Addendum 128 – UN Regulation No. 129

Revision 4 - Amendment 11

04 series of amendments – Date of entry into force: 15 June 2024

Uniform provisions concerning the approval of Enhanced Child Restraint Systems used on board of motor vehicles (ECRS)

"4.14. Additional markings

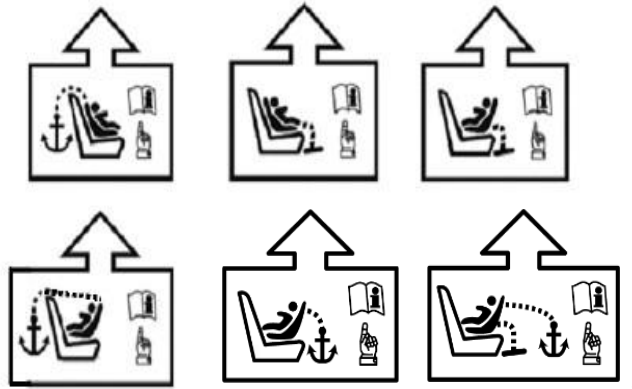
Paragraph 4.14., amend to read:

- (c) The position and if necessary, the routing of top tethers, lower tethers, or other means of limiting Enhanced Child Restraint System rotation requiring action by the user, shall be indicated using one or more of the following symbols as appropriate:

Figure 3 (f)
Generic Lower Tether Bracket

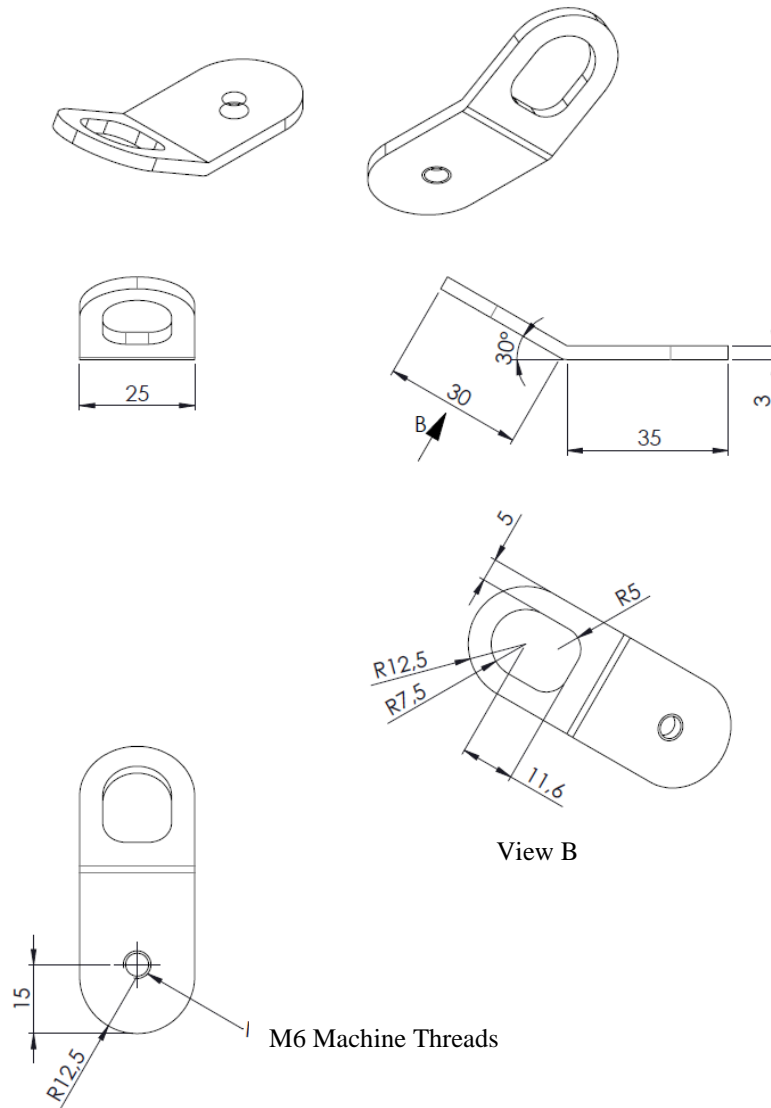
- 6.3.7.2. Dimensions bracket:
- (a) The generic lower tether bracket shall have dimensions according to Figure 3 (f);
 - (b) The outer edges of the lower tether bracket shall be at least blunted.

Figure 3 (g)
M6x8 Flange Buttonhead Hexagon Socketcap Screw (ISO 7380-2)

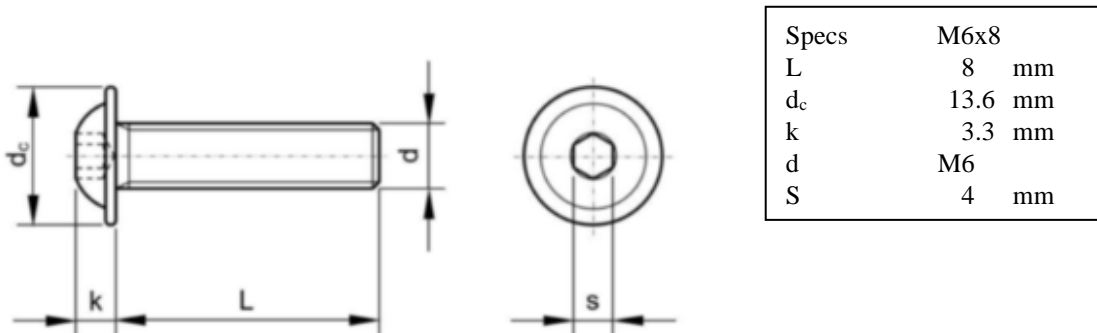
- (a) M6x8 flange buttonhead hexagon socket-cap screw see figure 3 (g);
- (b) M6 washer; see figure 3 (h);
- (c) M6 -8 shoulder washer; see figure 3 (i).

Figure 3 (j)
Test 1

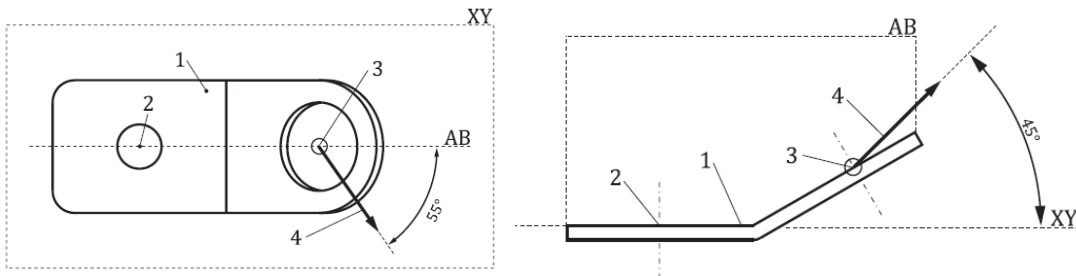
Two tests shall be performed; See figure 3 (j) and 3 (k)

(a) the force shall be applied in a direction of 55° ± 5° against plane AB, measured in a plane parallel to the rigid surface XY, and a direction of 45° ± 5° against the rigid surface XY, measured in plane AB; rotation around the anchorage point to vehicle (2) shall be prevented. see figure 3 (j);

Figure 3 (k)
Test 2

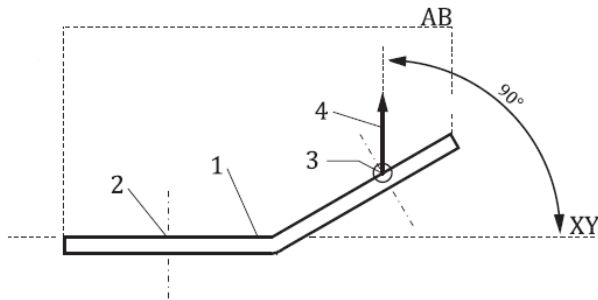
(b) the force shall be applied in a direction perpendicular (90 ± 5°) to the rigid surface XY.

Test Arrangement for a Rearward-Facing Device, not supported by the dashboard

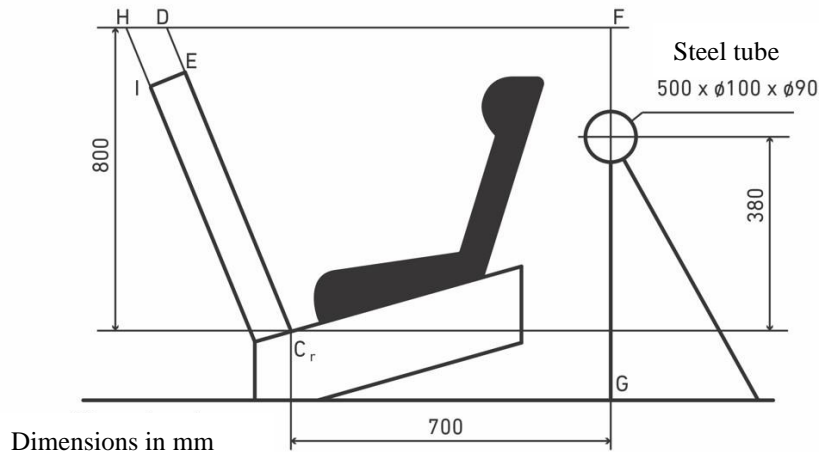
Figure 5, amend to read:

Arrangement and Use of Anchorages on the Test Trolley

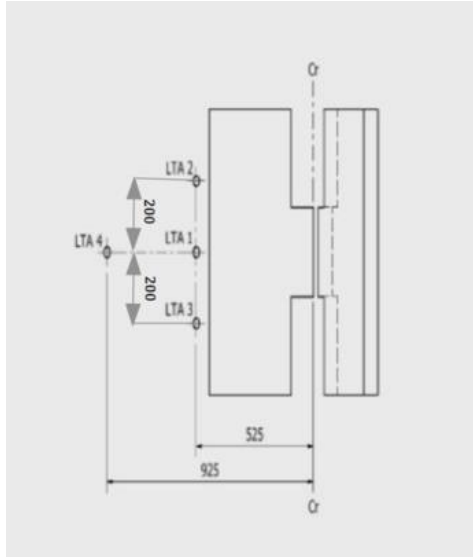
Annex 6, Appendix 2, amend to read:

5. For the testing of Enhanced Child Restraint Systems with lower tether(s), the floor shall be placed in its lowest position. LTA 4 is to be used in case the top tether anchorage from the seat in front is used. Otherwise LTA 2 and LTA 3; see figure 5. Generic lower tether brackets to be used for the dynamic test in case they are provided by the CRS manufacturer.
